Public Bidding No. 19-156-2
Malolos-Clark Railway Project (Blumentritt Extension) CP S-01
Building and Civil Engineering Works for Apx. 1 Km of Viaduct Structure Including Station Building at Blumentritt

BID CLARIFICATION REQUESTS (BATCH NO. 2)
GENERAL BID BULLETIN NO. 12

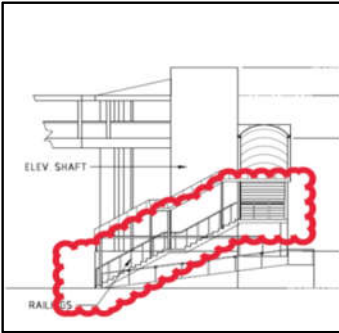
34	Volume 2, Part II, Section 6, II Drawings	NSRP-DWG-BLU-ST-4504	Book 2 of 2		Regarding Elevated Walkway steel size, image below shows the blow up detail of roof framing plan of elevated walkway. However one of steel item at expansion joint has no indication. Shall we assume this steel to be SB4? Please confirm.	<i>Refer to NSRP-DWG-BLU-ST-4504 in addendum 3 issued under GBB No. 10</i>

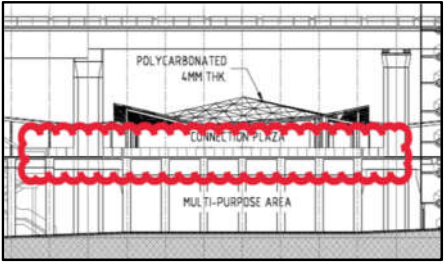
37	Volume 2, Part II, Section 6, II Drawings	NSRP-DWG-BLU-ST-4723	Book 2 of 2		Regarding Pedestrian Overpass steel stair connection plates and bolt, image below shows the steel framing plan for pedestrian overpass steel stair. Since the detail did not provide a connection detail, shall we assume 15% of total weight for steel plates and bolts? Please confirm.	<i>Please refer to TS 408 for measurement guidance. Quantities in the BOQ for the structural steel works are deemed to include weight for connection plates, base plates, and other components and accessories which may be needed to complete work, unless otherwise provided for as a separate pay item.</i> <i>Bidders may include all other allowances, including tests and other incidentals, in the calculation of rates/unit rates.</i>
38	Volume 2, Part II, Section 6, II Drawings	NSRP-DWG-BLU-ST-4723	Book 2 of 2		Regarding steel size, image below shows steel frame for stair. However one of steel item DB3 was not on the steel table. Please provide steel size for DB3	<i>Refer to NSRP-DWG-BLU-ST-4723 in Addendum 3 issued under GBB No. 10</i>

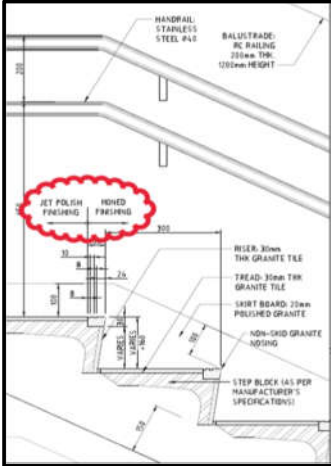
49	Volume 2, Part II, Section 6, II Drawings	NSRP-DWG-BLU-AR-3515	Book 2 of 2		At NSRP-DWG-BLU-AR-3515 FLOOR PLAN DETAIL 1 (Grid A to B/ 1 to 2, 10 to 11, 18 to 19), may we assume exterior wall finish to be Water Based Elastomeric Paint?	<i>Refer to NSRP-DWG-BLU-AR-3569 in addendum 3 issued under GBB no. 10.</i>
50	Volume 2, Part II, Section 6, II Drawings	NSRP-DWG-BLU-AR-3201	Book 2 of 2		At NSRP-DWG-BLU-AR-3201 ELEVATION SHEET 1, please provide the specification and detail of the clouded portion below. 	<i>Loading dock Rubber Buffer. (3-95mmx905mmx100mm rubber. The Drawing will be updated and issued in the next addendum or in the IFC</i>

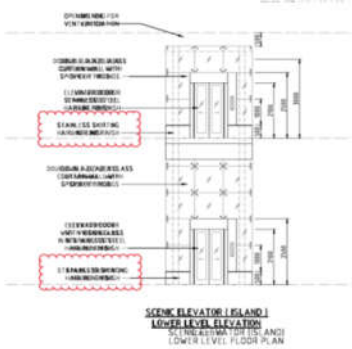
No.	Volume & Section No.	Page No.	Clause No./Title	Reference Text	Clarification Request	<i>Final Response</i>
96	Volume 2, Part II , Section 6, II Drawings	NSRP-DWG-STA-AR-3504, NSRP-DWG-BLU-AR-3901 to 3903	Book 2 of 2		<p>Wall Fire Rating differs as follows, NSRP-DWG-STA-AR-3504 GENERAL STATION TYPICAL DETAILS WALL</p> <p>2</p> <p>··· 4 hrs. Fire Rated NSRP-DWG-BLU-AR-3901 to 3903 BLUMENTRITT STATION FIRE COMPARTMENT AND FIRE ESCAPE ROUTE PLAN</p> <p>··· 2 hrs. Fire Rated and Non-Fire rated</p> <p>May we assume the one indicated at NSRP-DWG-BLU-AR-3901 to 3903 BLUMENTRITT STATION FIRE COMPARTMENT AND FIRE ESCAPE ROUTE PLAN, 2 hrs. Fire Rated to be correct?</p>	<p>NSRP-DWG-BLU-AR-3901 to 3903 BLUMENTRITT STATION FIRE COMPARTMENT AND FIRE ESCAPE ROUTE PLAN, 2 hrs. Fire Rated to be followed. The Drawing will be updated and issued in the next addendum or in the IFC</p>

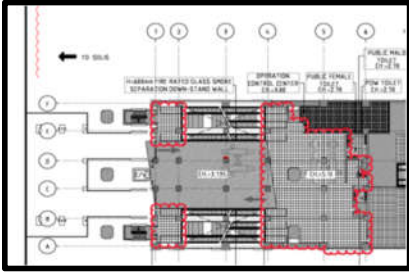
98	Volume 2, Part II , Section 6, II Drawings	NSRP-DWG-STA-AR-3031	Book 2 of 2		<p>At NSRP-DWG-STA-AR-3031 GENERAL STATION SCHEDULE OF FINISHES SHEET 1 Ground Level Blower Room for Waste Water Treatment Plant, there are 2 kinds of wall finish (WF2: Semi-Gloss Latex Paint on wall and 12mm thk. Cellulose Fiber Insulated Acoustic Panel) indicated, may we consider the entire wall finish to be WF2: Semi-Gloss Latex Paint on wall?</p> <p>Moreover, If 12mm thk. Cellulose Fiber Insulated Acoustic Panel is needed, Please provide its construction range..</p>	<p>Use Semi-Gloss Latex Paint on wall (WF2). The Drawing will be updated and issued in the next addendum or in the IFC</p>

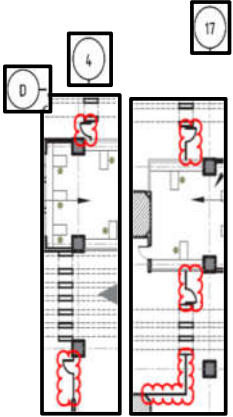
No.	Volume & Section No.	Page No.	Clause No./Title	Reference Text	Clarification Request	<i>Final Response</i>
119	Volume 2, Part II, Section 6, II Drawings	NSRP-DWG-STA-AR-3504, Part II - Requirements, Section 6 - The Employers Requirements, Part 1 The Specifications, Book 5-TS 500 Architectural(TS 500-56)			<p>Regarding the Interior Wall Composite Panel, specification differs as follows,</p> <p>NSRP-DWG-STA-AR-3504 GENERAL STATION TYPICAL DETAILS WALL 2</p> <p>··· 150mm thk with 20mm Coating on both sides Macro Air ICC-5 System Insulated Composite Wall</p> <p>Part II-Requirements, Section 6 - The Employers Requirements, Part 1- The Specifications, Book 5-TS 500 Architectural(TS 500-56)</p> <p>··· 100mm thk Composite Wall System consisting of Expanded Polysterene(EPS) and SABIE Alternative Building System (SABS) Structural Coating.</p> <p>May we assume the one indicated in NSRP-DWG-STA-AR-3504 GENERAL STATION TYPICAL DETAILS WALL 2, 150mm thk with 20mm Coating on both sides Macro Air ICC-5 System Insulated Composite Wall to be correct?</p> <p>Also, please give the Pay Item Number for this material.</p>	<p>NSRP-DWG-STA-AR-3504 GENERAL STATION TYPICAL DETAILS WALL 2, 150mm thk with 20mm Coating on both sides Macro Air ICC-5 System Insulated Composite Wall to be followed.</p> <p>The Drawing will be updated and issued in the next addendum or in the IFC</p>

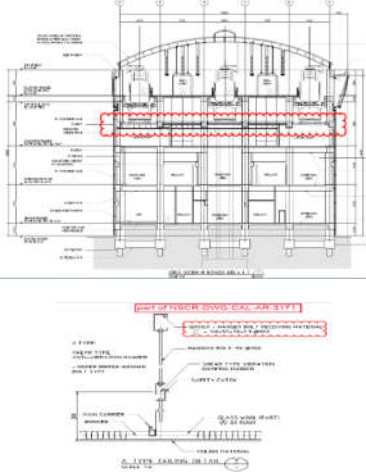
225	Vol. 2, Part II, Section 6, Part 1 Vol. 2, Part II, Section 6, Part 1	GS 91 TS700 - 97	Book 1, GS100 128.1 - General Book 6, TS700 TS708.2.2 - Ballasts	<p>As stated, "The Defect Notification Period (DNP) shall be twelve (12) months from the date of issue of the relevant Taking Over Certificate".</p> <p>As stated, "Item No. 4) c) Three (3) years warranty"</p>	<p>Please clarify and confirm if which one is correct and to be follow for the Ballasts warranty, it is one (1) year or three (3) years. This is for our pricing reference and condition.</p>	<p>it is one (1) year.</p>

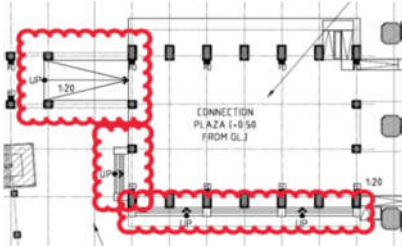
No.	Volume & Section No.	Page No.	Clause No./Title	Reference Text	Clarification Request	<i>Final Response</i>
229	Vol. 2, Part II, Section 6, Part 1	TS700 -139	Book 6, TS700 TS713.2.7 - Building Management System (BMS)	As stated, "Item No. 3) b) iii) Chiller Plant Optimization"	Please clarify and confirm if there is a need for the Chiller Plant Optimization under BMS system. Yes or No.	No Chiller Plant in S-01
230	Vol. 2, Part II, Section 6, Part 1	TS700 -144	Book 6, TS700 TS713.5.1 - Method of Measurement	As stated, "Item No. 4) 42" LED Display	Please clarify and confirm that Bidders / Contractors can follow the size of 42" LED Display for the BMS monito for pricing purposes. Yes or No.	Refer to the requirement in TS.
231	Vol. 2, Part II Section 6, Part II	NSRP-BLU-DWG-EL-5001, REV9	Blumentritt Station - Electrical General Notes Abbreviations and Legend	LEGENDS	<p>1.) As shown in the LEGENDS, please clarify and confirm if the following are under CP S01 scope of works. Yes or No. eHG-03 - Directional Sign sHG-01 - Way Finding and Time Table eWD-02 - Free Standing Billboard ePST-01 - Station Name (400mm x 600mm)</p> <p>2.) If "YES", please provide details, specifications, BOQ Pay Item No. and other related required information for our pricing purposes.</p>	<p>1. Yes, all 4 items mentioned are under CP S-01 scope, divided between Architectural Works scope and Electrical Works scope.</p> <p>Architectural Works scope will be the whole of the Signage (i.e. Signage, lighting, foundation/supports) and wiring/cables to tap to power source.</p> <p>Electrical Works scope covers all works to supply power to the Signage through a junction box installed at the location of the signage.</p> <p>2. Quantities of works for the Electrical scope are included in the following Pay Items: PIN 707(8)h, 703(1)as7, 703(1)as8</p> <p>For detail please refer to NSRP-DWG-BLU-EL-5403 to 5410 & specification TS 701.3.3 for Electrical.</p>

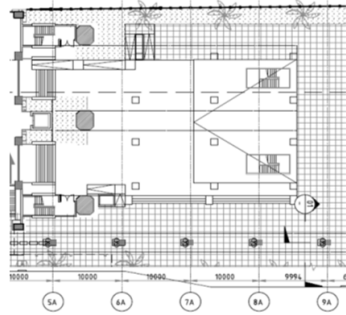
No.	Volume & Section No.	Page No.	Clause No./Title	Reference Text	Clarification Request	<i>Final Response</i>
232	Vol. 2, Part II Section 6, Part II	NSRP-BLU-DWG- EL-5101, REV9	Blumentritt Station - Electrical Earthing Schematic Ground Level	Earthing Busbar	Please provide the detail and dimension for the Earthing Busbar for our pricing purposes.	600mm x 50mm x 6.35mm (L x W x Thickness).Refer to NSRP-BLU-EL-DWG--5101 .Added the size of the earthing busbar.
233	Vol. 2, Part II Section 6, Part II Vol. 1A, Part I	NSRP-BLU-DWG- EL-5403 to 5414, REV9 NSRP-BLU-DWG- EL-5500 to 5512, REV9 BOQ - 57	Blumentritt Station - Electrical Lighting Lay- Out Blumentritt Station - Electrical Panel Board Schedule Section 4A- Bill of Quantities BOQ Item No. 707 - Conduit for Lighting and Receptacle/Po	Type of Conduit and Sizes for Lighting and Receptacle / Power	Please provide and shown in the plan the correct type and sizes of conduits for Bidders / Contractor reference in relation with the breakdown BOQ under BOQ Pay Item Nos. 707(8)h, 707(2)b and 707(9)c.	Kindly refer to revised NSRP-BLU-EL-DWG-5500 .Added the size and type of conduit.

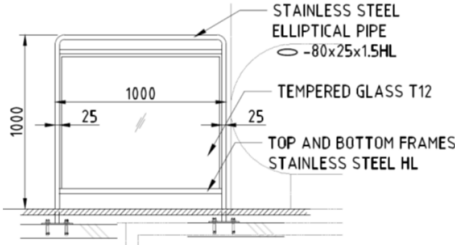
No.	Volume & Section No.	Page No.	Clause No./Title	Reference Text	Clarification Request	<i>Final Response</i>
235	Volume 2, Part II, Section 6, II Drawings	NSRP-DWG-BLU-AR-3411	Book 2 of 2		<p>Regarding Ceiling Support - Architectural reference shows cross section of Station with ceiling finish that may need Secondary ceiling support, however architectural Typical details did not show any reference. Shall we follow other Station with ceiling detail NSCR-DWg-CAL-AR-3171 showing Girder-Hanger bolt receiving material C-100x50x20x2.3 @ 900 and H-100x100x6x8 @ 1800 and along concrete beam Please advise.</p> 	Refer to drawing sheet NSRP-DWG-BLU-AR-3411 and 3412.
